### PLANNING COMMISSION REGULAR DOCKET TUESDAY, September 11, 2018 at 5:30 P.M. CITY COUNCIL CHAMBERS

1. **SP18-00007: Gallery Court Hotel SUP Request** - Vipul Patel of Incaam Hotels, LLC, has submitted an application seeking approval of a Special Use Permit (SUP) for the property located at 140 Emmet St N. The property is further identified on City Real Property Tax Map 8 as Parcel 4 ("Subject Property"). The Subject Property is zoned URB, EC (Urban Corridor Mixed Use District, with Entrance Corridor Overlay). The owner is seeking to redevelop the property as a hotel to replace an existing hotel that was lost by casualty (fire) on May 4, 2017. The proposed use ("hotels/motels") is allowed by-right within the URB zoning district classification. However, an SUP is required for the project because the proposed building height (seven (7) stories, up to 80 feet) exceeds the 60-foot maximum building height allowed in the URB District. The site is approximately 0.585 acre or 25,482.6 square feet. The Comprehensive Plan designates the land use of the Subject Property as Public or Semi-Public. Information pertaining to request may be viewed online at <http://www.charlottesville.org/depar

SLOPES >25% SLOPES ARE NOT CRITICAL BECAUSE THIS AREA IS LESS THAN 8000 SQ. AREA=5,921 SF

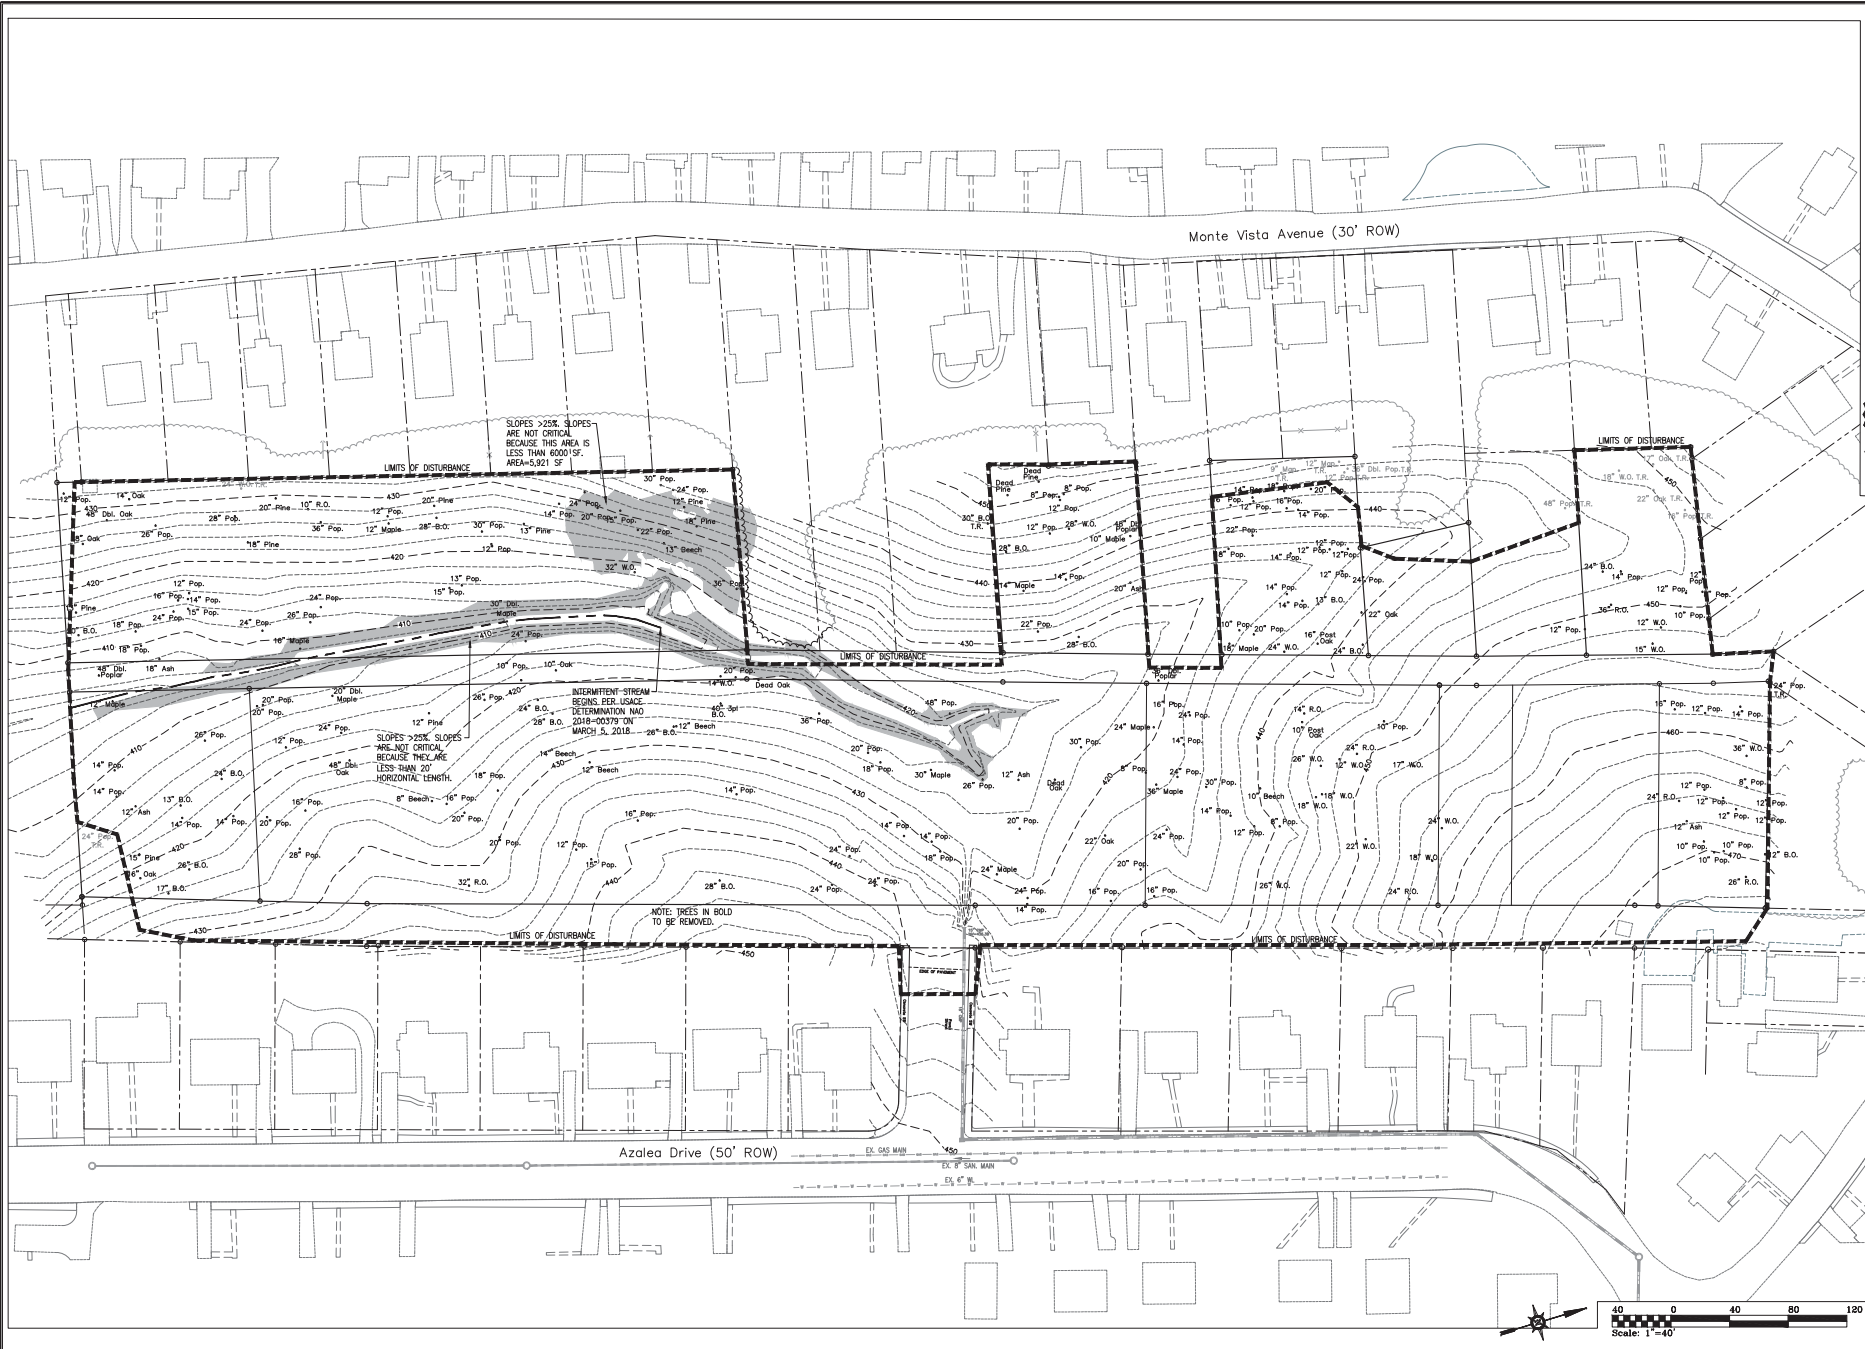
2. Sheet C2 – the applicant states that the slopes along the intermittent stream do not qualify as critical slopes because they are less than 20' horizontal length. However, the slopes that are indicated to be greater than 25% slopes that are along the intermittent stream appear to be well in excess of 20' of horizontal run. What is the applicant's basis for stating that these slopes do not meet the 20' horizontal run requirement? Additionally, the applicant states that the slopes along the hillside do not qualify as critical slopes because they are less than 6,000 square feet (the applicant calculates that they are 5,921 square feet). However, there are several portions within this area that have been omitted from the >25% slope area calculation. They show up as white “holes” within the dark hatched area (see image below).

Date: 01/19/2018  
 Scale: 1"=40'  
 Sheet No.: C4 OF 15  
 File No.: 17.052

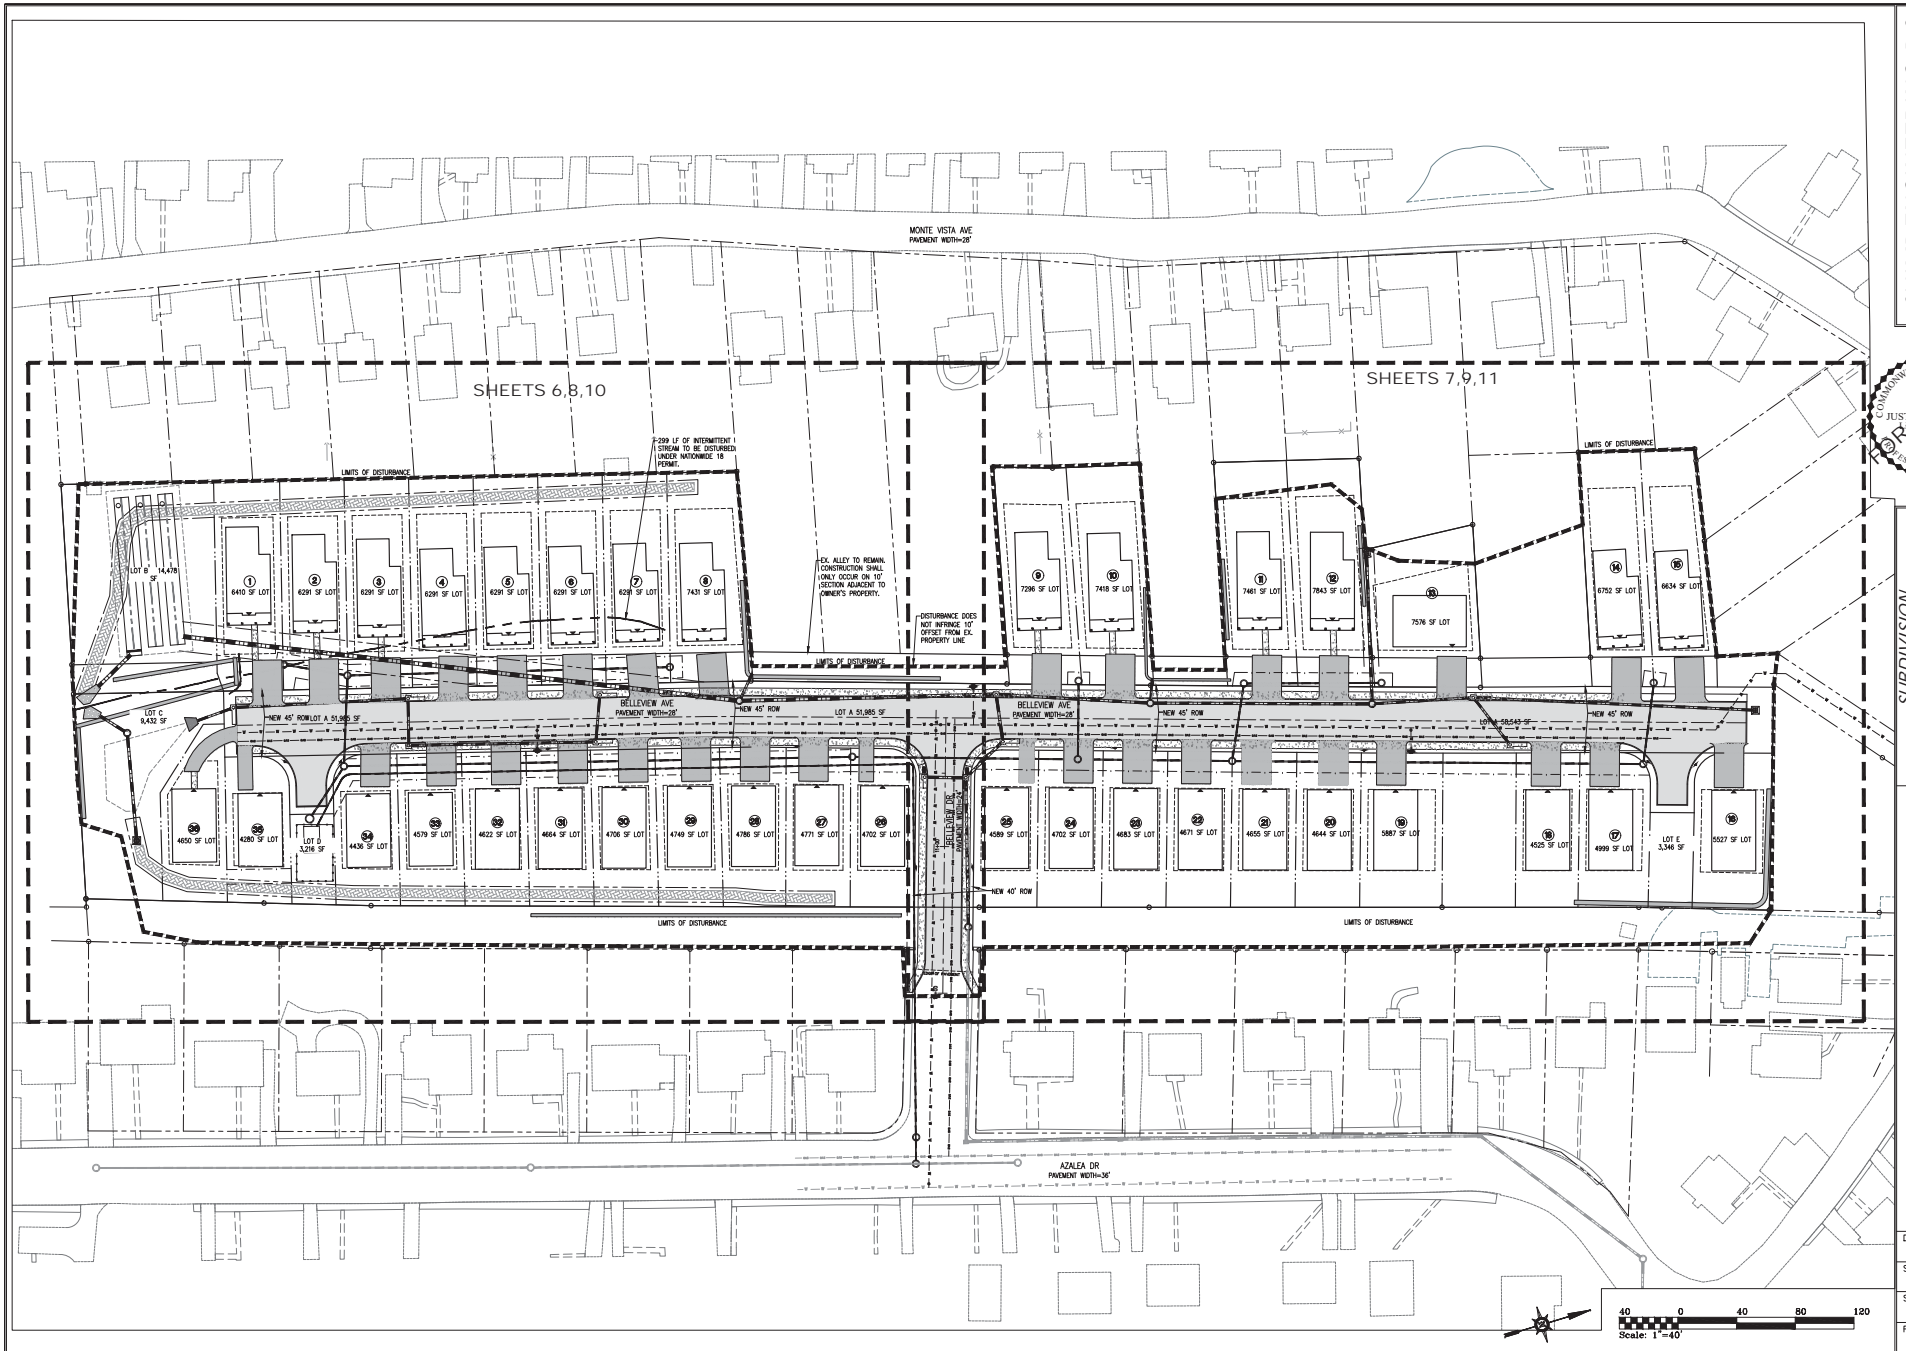
**Question 2: is Lot A (61,885 SF) a lawful lot?** On Sheet C4 of 15 the Landowner depicts a new Lot A to be created within this Subdivision Plan. Lot A is shaped like a “T”. If this Subdivision Plan is approved by the Commission, this lot will not be developed for residential occupancy. According to the Landowner’s representative (Mr. Shimp), at a later date, Lot A would be developed as a public street—as a stand-alone development project—and the 20-foot alley would be vacated or combined into the lots adjacent to the north. (Lots 1-15). The purpose of showing the “T” area as a new lot, rather than a dedicated public ROW, is not clear [*other than to avoid review as a major subdivision? Review of a “boundary line adjustment” plat is by the NDS Director, per Subdivision Ordinance §29-56(a)*].

**Planning Commission: is Lot D a lawful lot under the subdivision ordinance definition of “lot”? Does the zoning ordinance permit an existing lot to be used solely for Utility Facilities?** [See sheet C4 of 15 of the Subdivision Plans].

4. Please add "Preliminary" to the title block on all plan sheets.
5. Please clarify what is happening with the existing 20' alley and 30' street. On sheet C4, both are identified as to remain (as City ROW?) but on the other plan sheets these appear to be used as a part of the development area with retaining walls, utilities and driveways being constructed. If private infrastructure is constructed in these, then they need to be vacated so it is clear they are not City ROW.

DATE: 01/19/2018  
 SCALE: 1"=20'  
 SHEET NO.: C8 OF 14  
 FILE NO.: 17.052

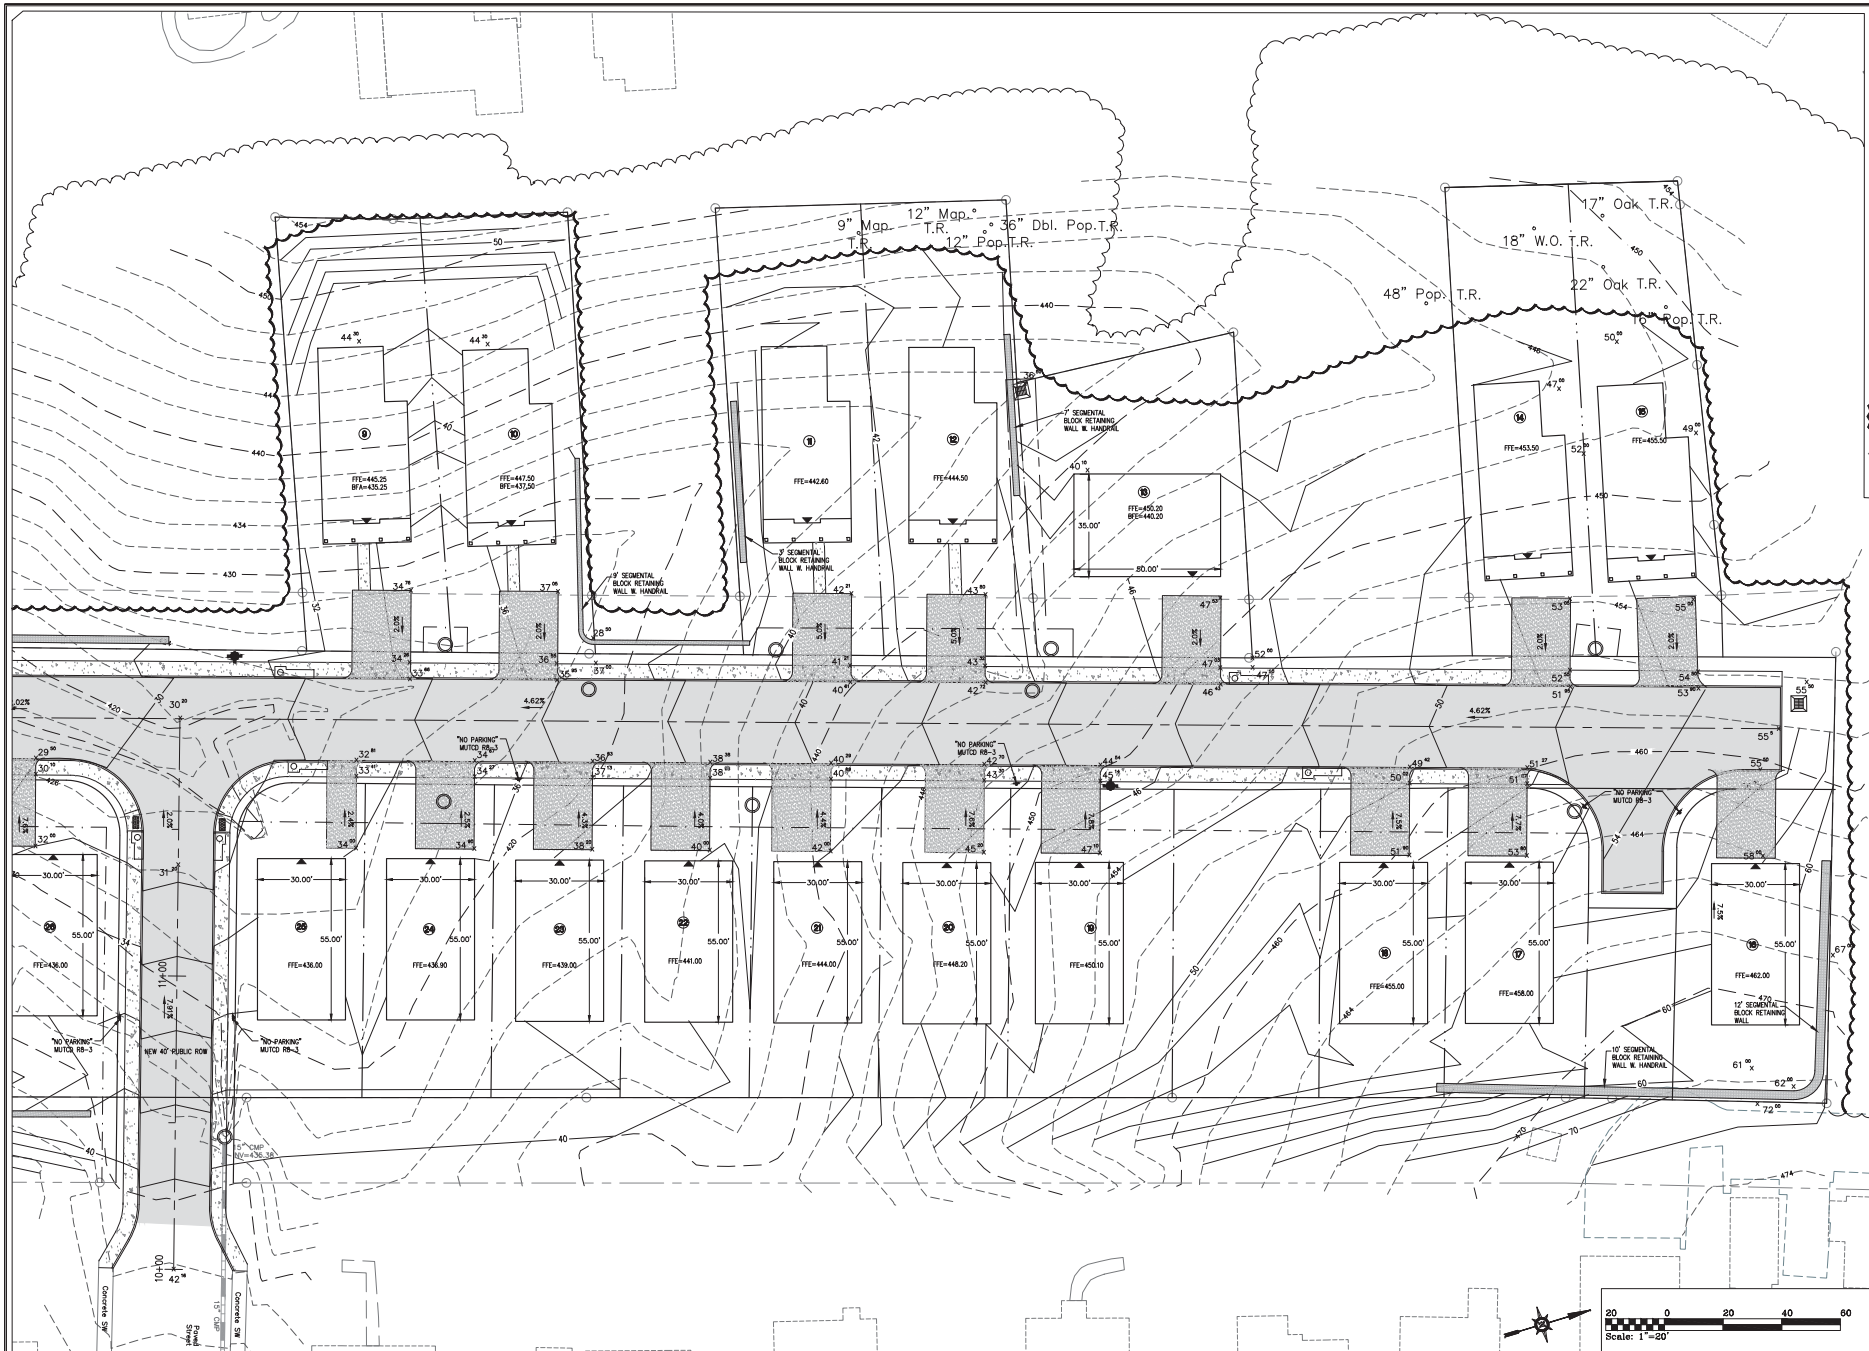
34. Remove retaining wall from alley.
35. Graphic scale and text scale are different.  
Sheet C7
36. Graphic scale and text scale are different.
37. Remove retaining wall from alley.  
Sheet C8 and C9
38. Construction activities not related to the building of a road cannot happen in the Belleview Street ROW without City Council approval or closure of the street. Closure of the street will also require City Council approval. **See Chapter 28 City Code, especially § 28-5.**  
Sheet C12
39. 48" Pop. T. R. is not within the development. Update canopy coverage.
40. Trees on lots 6 and 7 are not within 15' of the ROW.
41. Lot 36's tree is located in the driveway.
42. Lot 35's tree is in the sidewalk.
43. A more detailed landscape plan will be required with final site plan submission. **Note: landscaping must be provided in accordance Zoning Ordinance §34-867.**
